IMPROVED PICTURE TUBE REPLACES TYPE 21EAP4

Type 21FDP4, a picture tube featuring longer life through improved design characteristics, is now being recommended as the replacement for type 21EAP4.

Figure 1

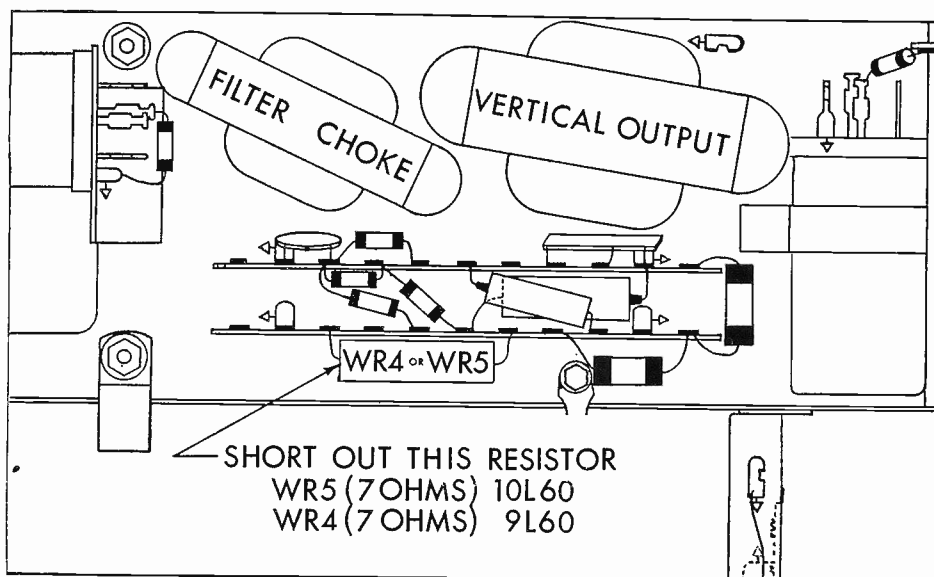
Briefly, replacement of the 21FDP4 for the 21EAP4 is as follows: For parallel wired Philco chassis 9L60, 9L60U, 10L60, and 10L60U, the filament dropping resistor shown in Figure 1 is shorted out. For series string heater Philco chassis 9L37, 9L37U, 9L38, 9L38U, 9L38A, and 9L38AU, the 8 ohm section of WR-3, illustrated in Figure 2 is shorted out.
